TO: Cannon Falls City Council
FROM: Neil Jensen, City Administrator
SUBJECT: FINAL PLAN APPROVAL FOR THE KELLER-BAARTMAN
APARTMENT COMPLEX
DATE: January 18, 2022

RE: Cannonball Apartments-Zoning Response

RE: Plan Revisions per review of Cannonball Apartments dated December 8th, 2021

RE: Plan Revisions per review(s) of Cannonball Apartments dated January 5th and via email
January 6, 2022

CANNONBALL APARTMENTS
SITE/GRADING PLAN
SHEET 1
OF 2 SHEETS

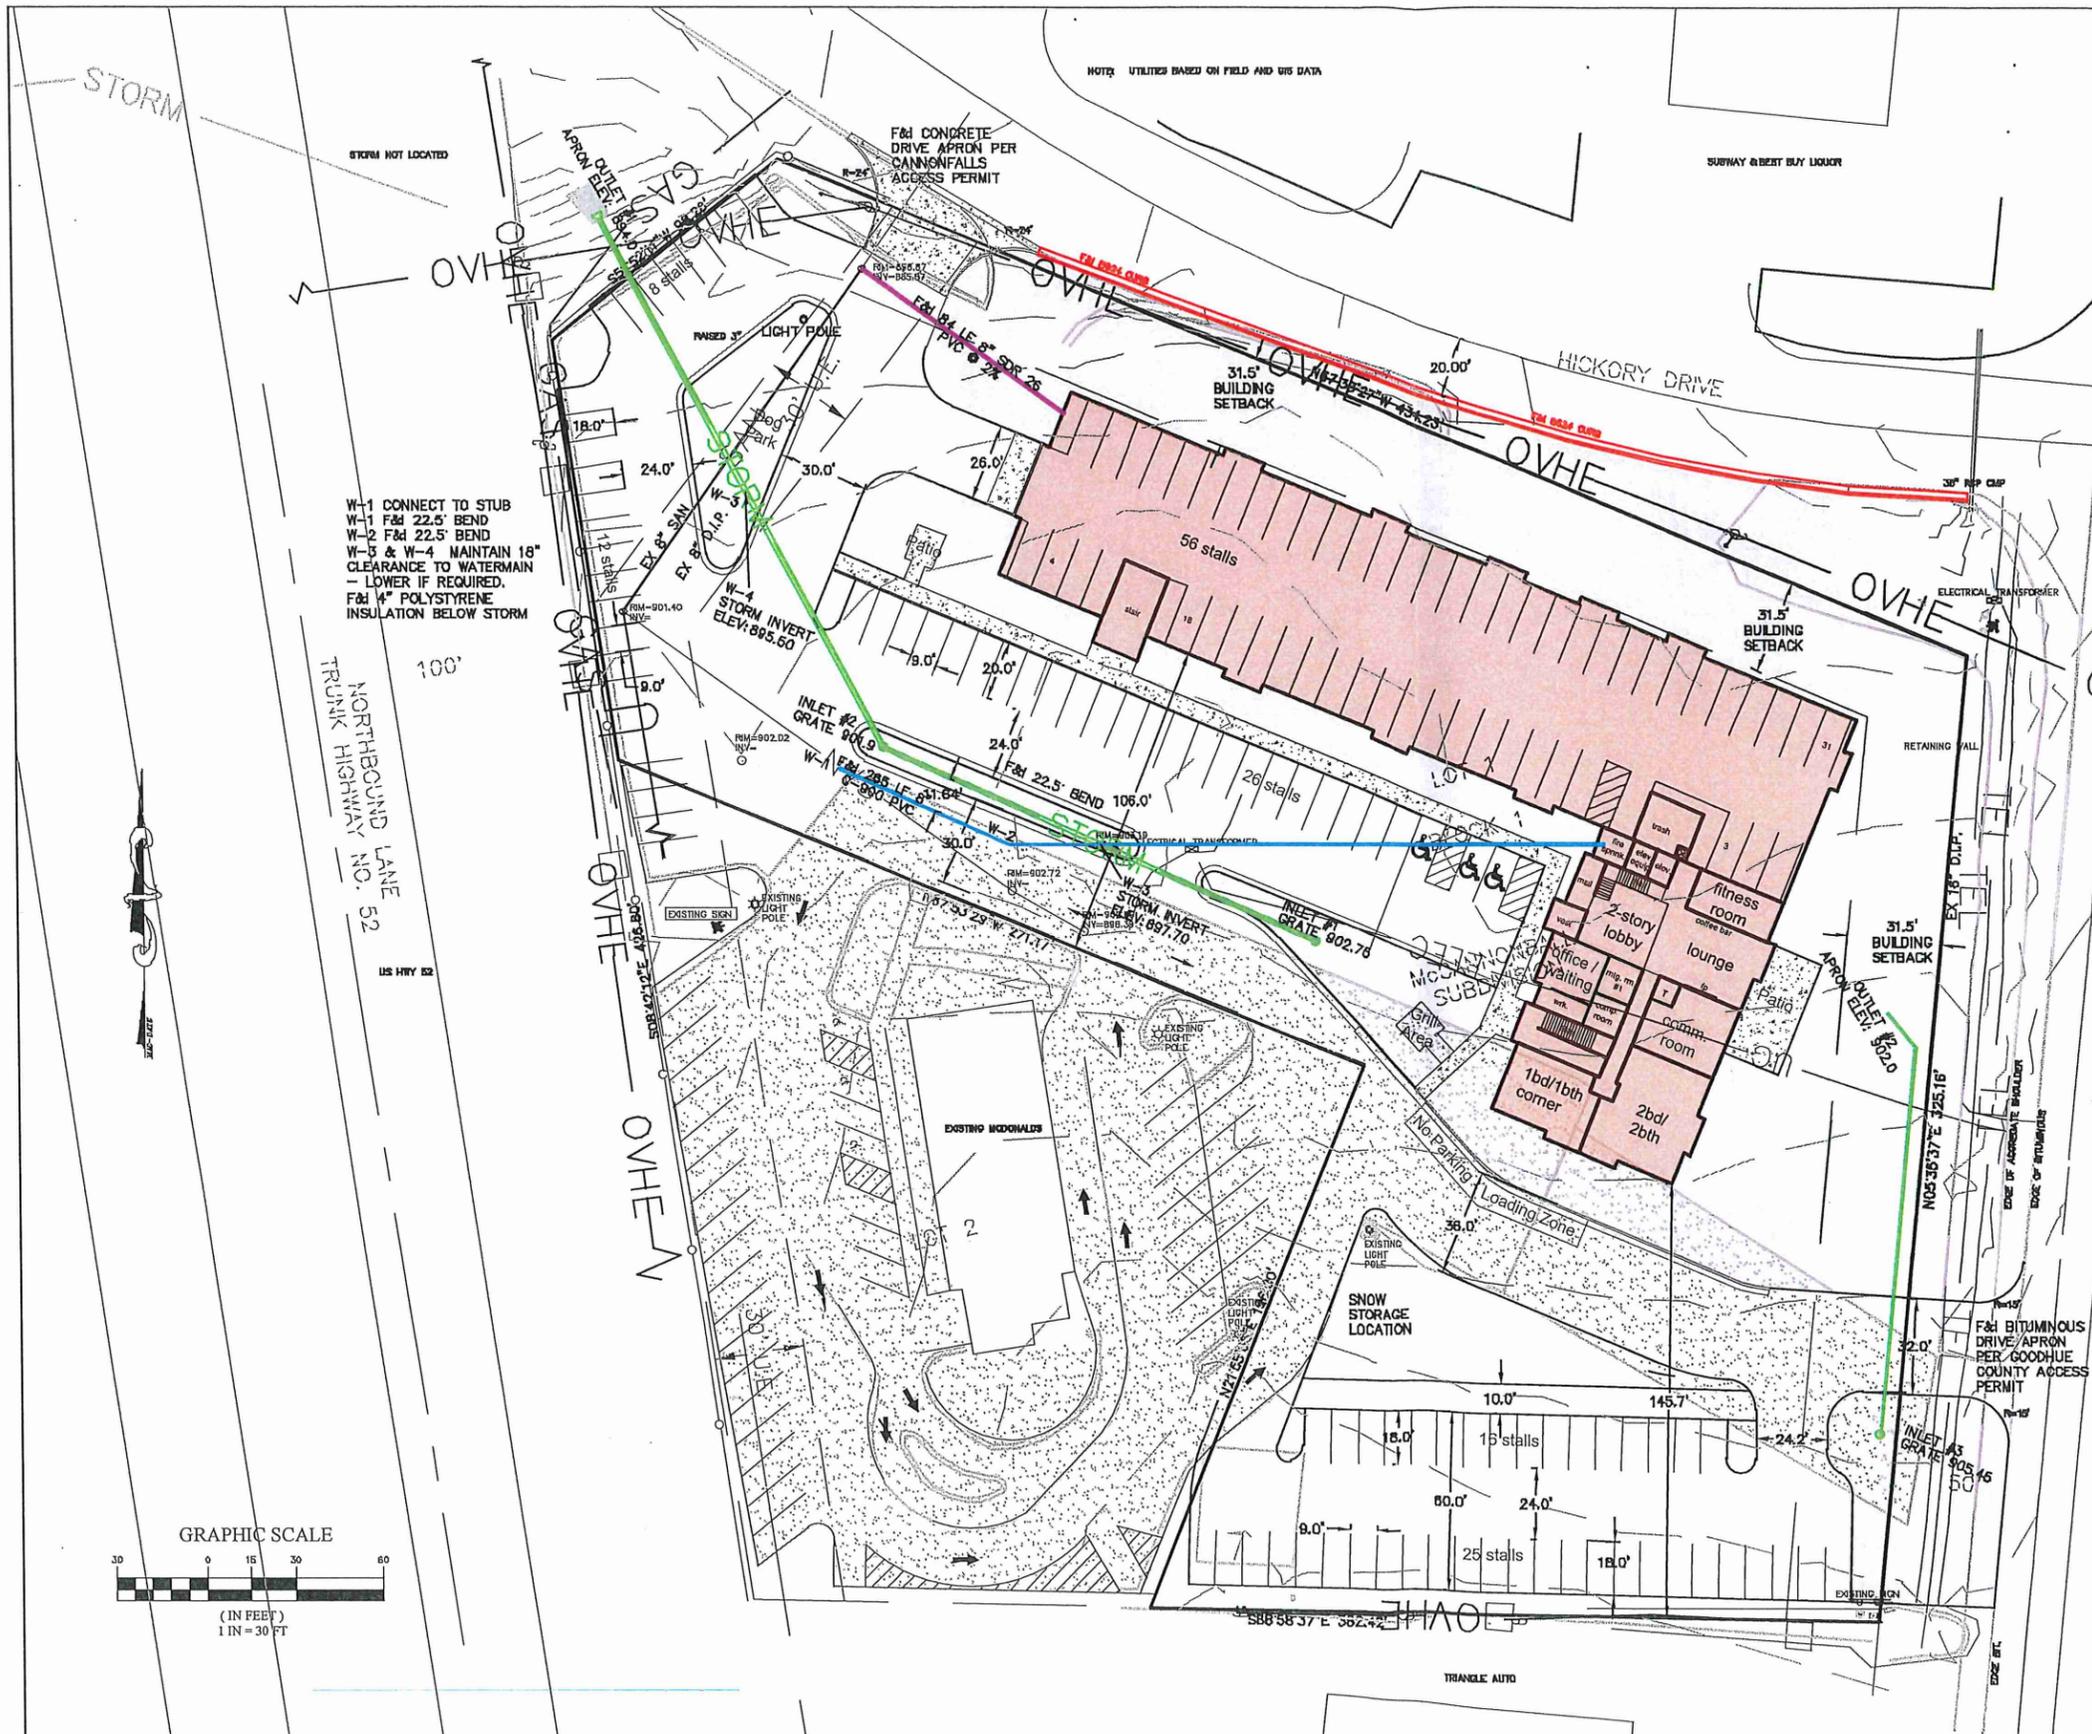
SURVEY – The dog park and curbing over the easement will require an agreement with the City regarding each party's responsibility for restoration if there is need for disturbance of the proposed improvement. This will need to be added to the Developer's Agreement.

TRAFFIC CIRCULATION – Signage must be installed along curb on south side of building to maintain an area for loading and unloading of vehicles. i.e. "No Parking – Loading Zone".

PARKING STALL IN SETBACK – A waiver will be required for the three parking stalls located in the northwest corner of the site plan, due mainly to the location and distance from the building.

6. The proposed sanitary service size was changed in the resubmittal to an 8-inch diameter pipe. An 8-inch inserta-tee connecting to the existing 8-inch main will not work. The proposed 8-inch sanitary service will need to be connected to the existing manhole just north of the proposed location.
9. A SWPPP was submitted for the project. A landscape and lighting plan were not submitted.
10. City staff should contact the fire department regarding hydrant spacing. Hydrant spacing appears adequate to us.
16. The stormwater runoff from the adjacent property to the south appears to drain through this Southeast area and sheet flows across the proposed driveway. A culvert beneath the driveway should be required to convey this drainage to the proposed drainageway to the north.

We have reviewed your comments and are in concurrence with the recommendations for the waivers and agreements referenced in your letter dated January 5th, 2022. We have made a plan revision to identify the "No Parking - Loading Zone" location on the south side of the building. Signage to that effect will be placed at either end of the loading zone. We are also making application for the necessary curb cuts/driveway relocations as requested by the County and City.

6 - We have revised the site/grading plan to add notes for a core and neoprene boot for the 8" service line to connect direct to the sanitary sewer manhole.

16 - The drainage in the southeast corner has a very small watershed and has functioned as sheet flow with more impervious surfacing for many years. Because of the lack of a ditch section along the roadway or enough elevation to put in a standard 12 or 15 inch culvert, we have called out an inlet structure connected to an 8" perforated PVC pipe which will run on the property to where it can outlet into the swale being formed east of the apartment building. This allows for a shallow depression where we are converting the existing impervious to grass which is better depicted on these updated plans.

SANITARY SEWER CONNECTION NOTE:
NEW 8" SDR 26 SEWER SERVICE SIZE SHALL BE CONFIRMED BY THE BUILDING MECHANICAL ENGINEER. CORE & BOOT TO THE EXISTING MANHOLE IS ANTICIPATED. MINIMUM SLOPE SHALL BE 2%.
